UNITED STATES PATENT AND TRADEMARK OFFICE  
**CERTIFICATE OF CORRECTION**

PATENT NO. : 7,060,017 B2  
APPLICATION NO. : 10/821562  
DATED : June 13, 2006  
INVENTOR(S) : Kevin E. Collier

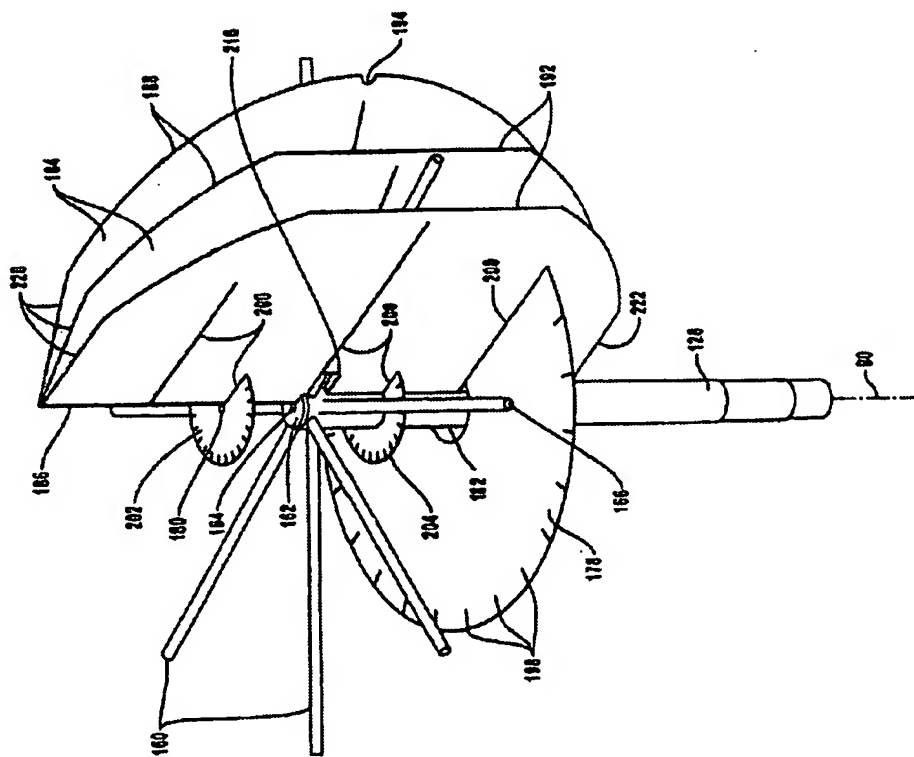
Sheet 4, replace Figure 5, with the figure depicted herein below, wherein the "central orifice" of "disk 178" has been labeled with --182--

FIG. 22

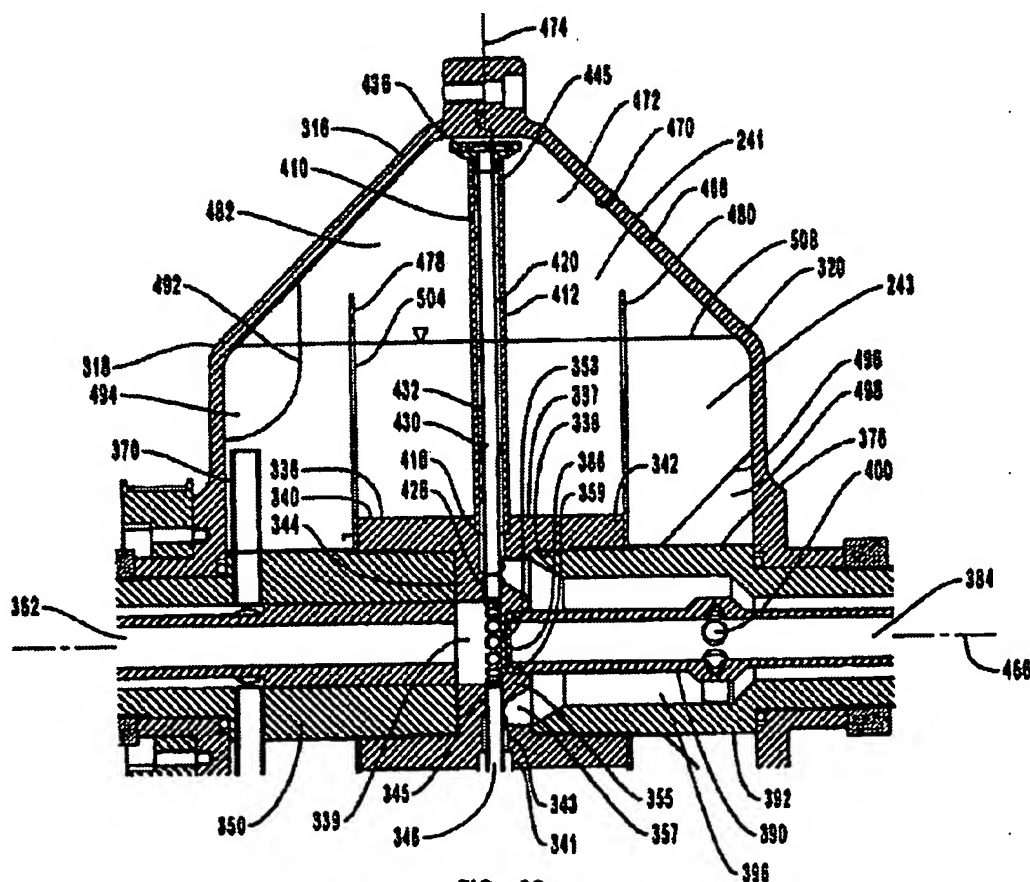
Sheet 21, replace Figure 22 with the figure depicted herein below, wherein the “nozzle” has been labeled with --436--

FIG. 24

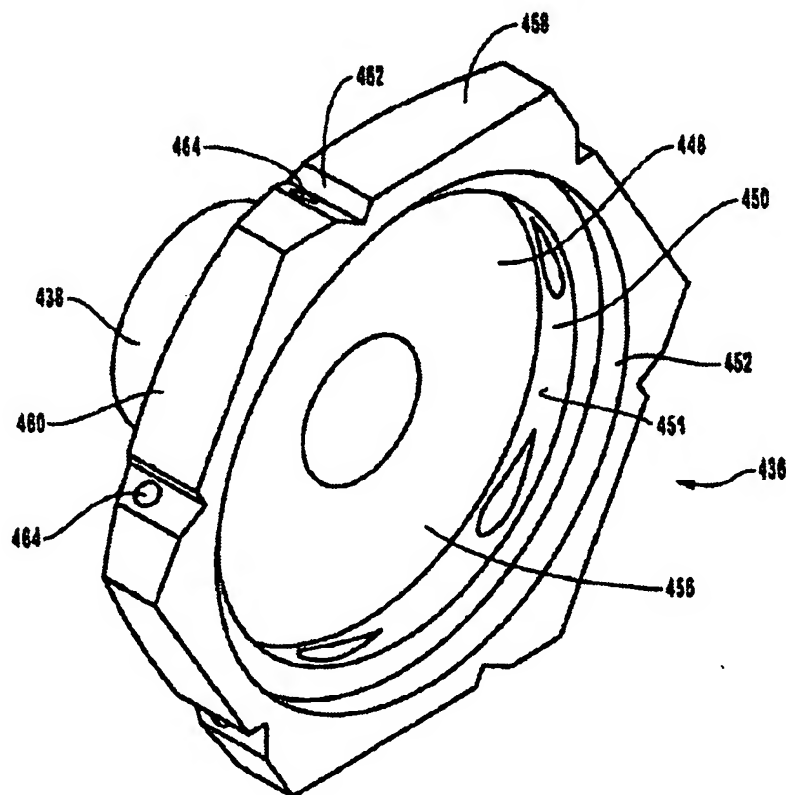
Sheet 23, replace Figure 24 with the figure depicted herein below, wherein the "interior surface" of "sidewall 450" has been labeled with --451--
